L A N D M A R K S
P R E S E R V A T I O N
C O M M I S S I O N

S T A F F R E P O R T

2113 Kittredge Street – California Theater

Structural Alteration Permit (#LMSAP2022-0011) to demolish the California Theater building while retaining and rehabilitating the primary façade, and to incorporate the façade into the construction of a new 18-story, mixed-use building featuring an approximately 24,000-sq. ft. performance venue and 211 dwelling units in the Downtown.

1 SOUTH ELEVATION
 A201 3/32" = 1'-0" ON 24X36 (3/64" = 1'-0" ON 12X18)

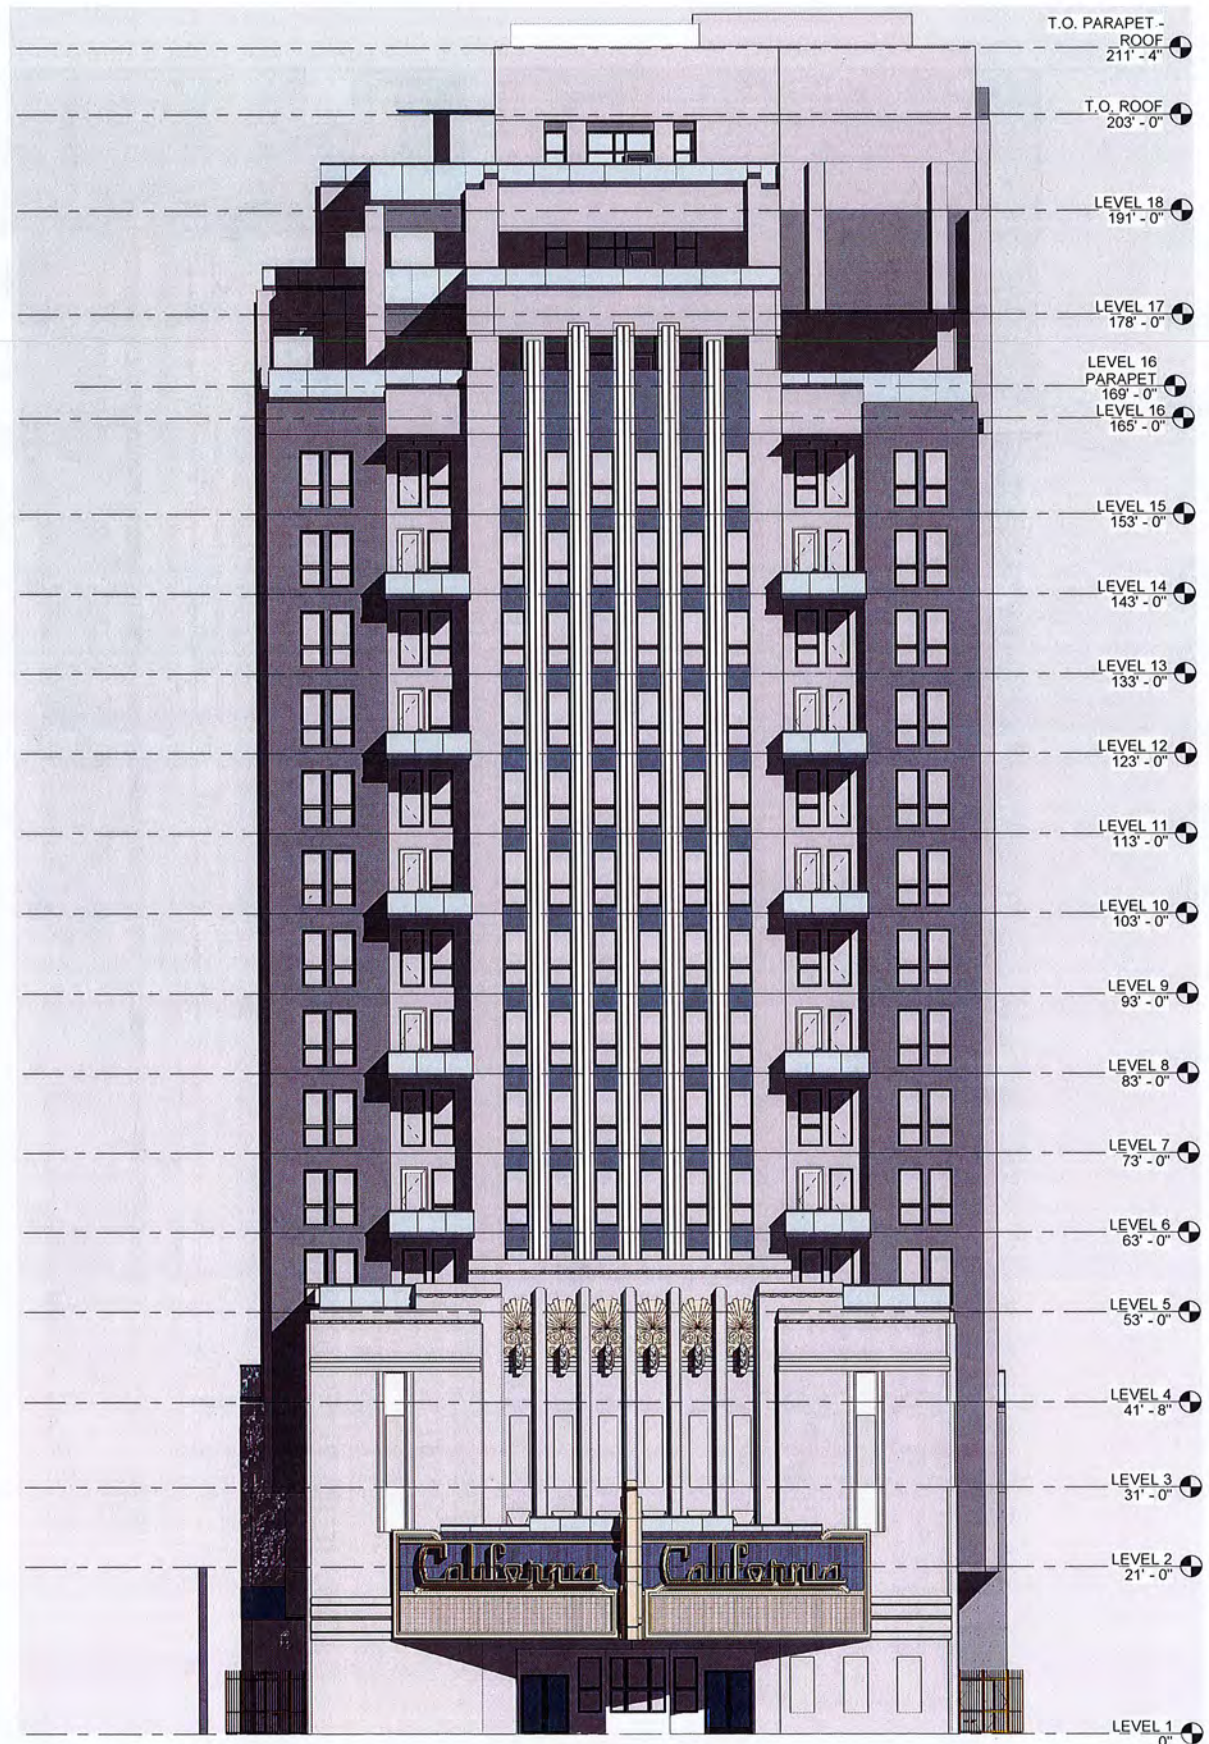
- 6. Confirm bird safe glazing.**
- The proposed project will use bird safe glazing. Elevations on Plan Set Sheet A201 through A204 include statements that bird-safe glazing will be utilized on this project.
